Our Reference: G21460L2B

26 September 2017

## **Lindum Vale PSP – VPA Road Network Traffic Engineering Review**

Figure 1: Boulevard Connector Cross-Section

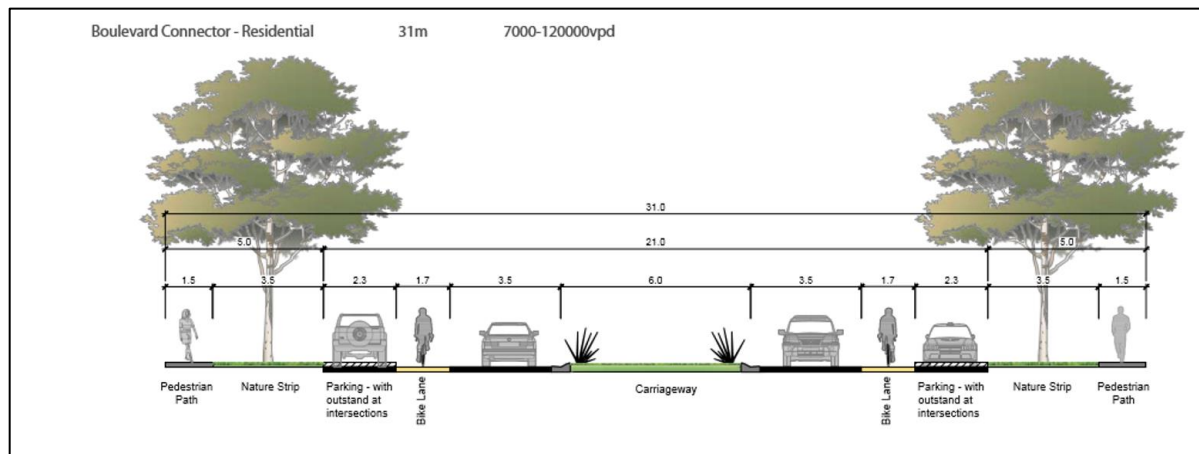
The boulevard connectors will have a cross section consistent with this road type approved within the Merrifield West PSP. The boulevard cross section is illustrated in Figure 1.

It is noted that the boulevard connector has a target volume range of 7,000 – 12,000 vehicles per day.

Given that the cross section for the boulevard connectors has essentially been established by approval of and construction of part of the boulevard connector in Merrifield West, we do not believe it is necessary for an arterial cross section to be provided.
